## Historical Cultural Resources Assessment Report: Hangar Building 527 West Almond Avenue & 180 South Cypress Street; Orange CA

Proposed Adaptive Reuse Development for the Friends Church Orange

**END OF NOTES: Planning Comments Response Memorandum, 17 OCTOBER 2025**

**Figure # 14: East secondary façade, showing proposed design alterations and AO Architects proposed East façade fenestration modifications.**

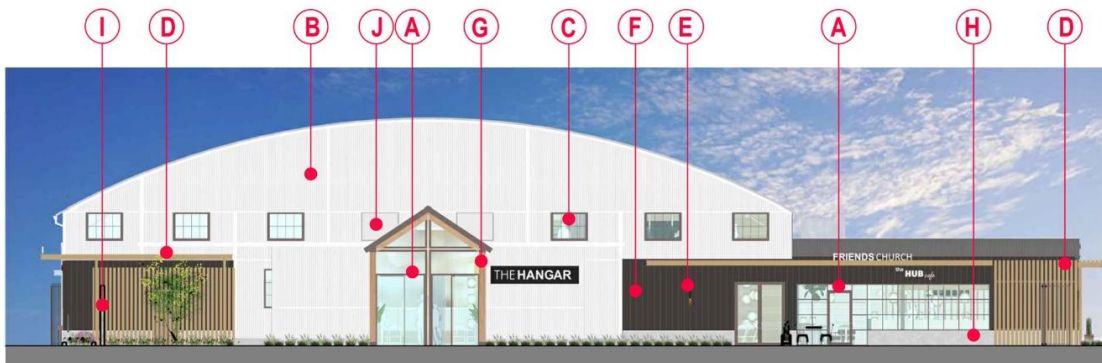
A coffee shop has an aluminum metal storefront window system proposed at the ground floor level of the northern addition. There are a total of 8 original second floor level “clerestory” windows at each of the four facades. At the east elevation as shown two new primary entrance doors are placed at the mid point of the façade. There are two original windows that are proposed to retain the original steel frame in place, as a “blind” window. Alteration of this east façade and mezzanine floor level has a beneficial reciprocal use for window replacement where louvres may be replaced.

Figure #19: east façade proposed design conditions elevation for comparative review. Refer to the existing window conditions seen in the existing condition elevation, Figure 18 above.

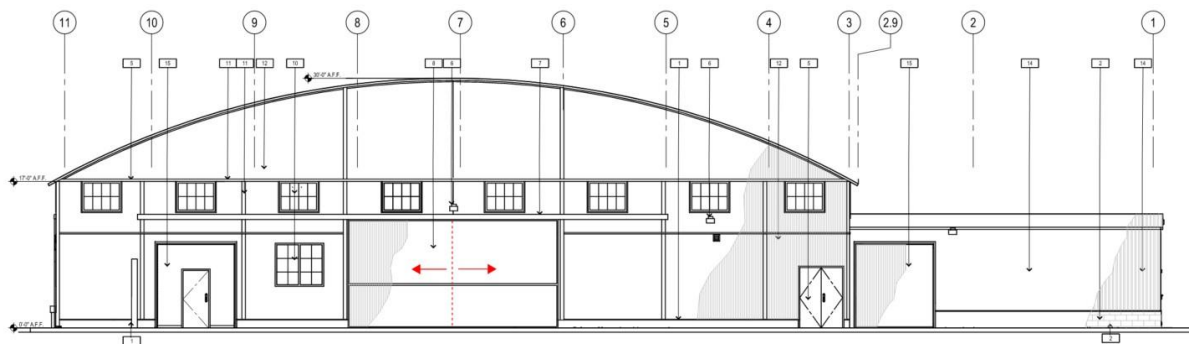
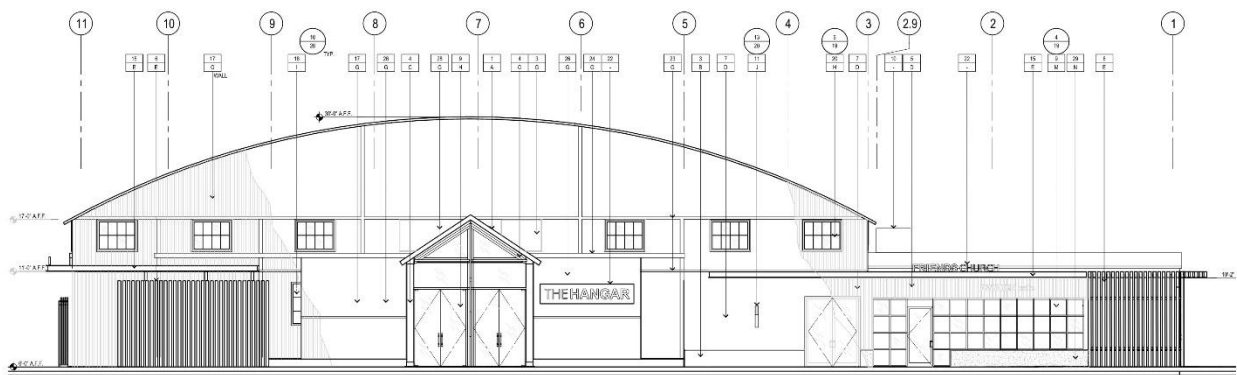
The east façade alteration as proposed; the main entrance doors and transom lites are set outside of the original Hangar Building exterior façade. All of the existing clerestory windows remain at areas except at the mezzanine location and will be rehabilitated in their existing original façade locations. Ground floor level storefront windows modify the north loading dock ramp area beyond and the mezzanine area above. Noted that the east elevation is not a primary street facing façade.

The two windows either side of the proposed entrance doorway may be laylights to gain natural overhead interior lighting in the vestibule. The Coffee shop at the northern portion of the east façade (at the far right) represent an alteration of the northern loading dock façade and not of the Hangar Building.

We recommend retaining the two existing sliding door panels, allowing for the new entry which is a precedent of the original location of the entranceway reconstruction. It may be perceived as a bit quirky with the juxtaposition of sliding door facade panels and window, but we believe it is consistent with the warehouse narrative and the sense of progression of program and function per SoIS #3,

Figure # 21: Proposed overall site plan AO Architects sheet number 01

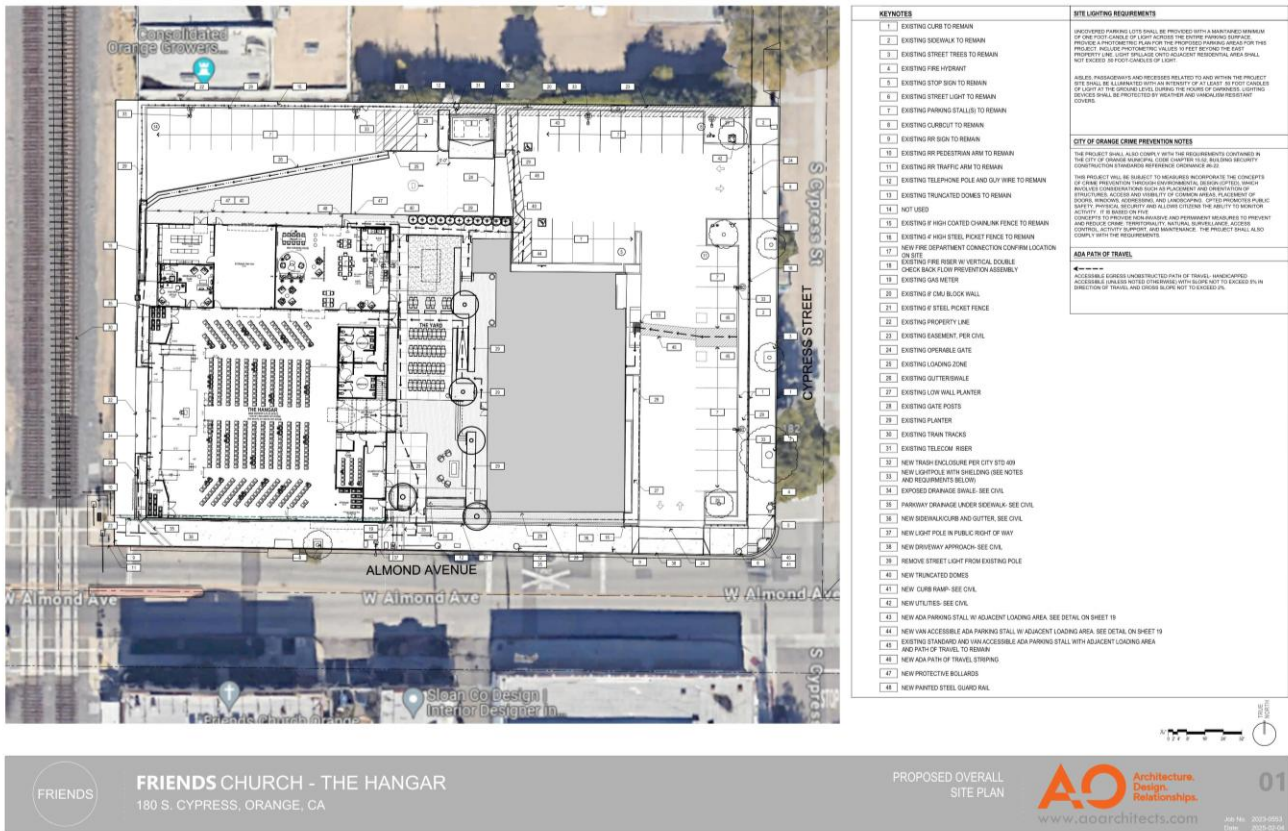
A further justification for alterations to this secondary east façade is the introduction of a primary entrance glazed door units in that Secondary façade. The location of a later alteration to the Hangar interior is by the later construction of a mezzanine floor level. At the ground floor level a proposed coffee shop at the east and north elevations- neither of which is located at a street visible, Primary façade- the Rehabilitation standards allow for an adaptive reuse strategy.
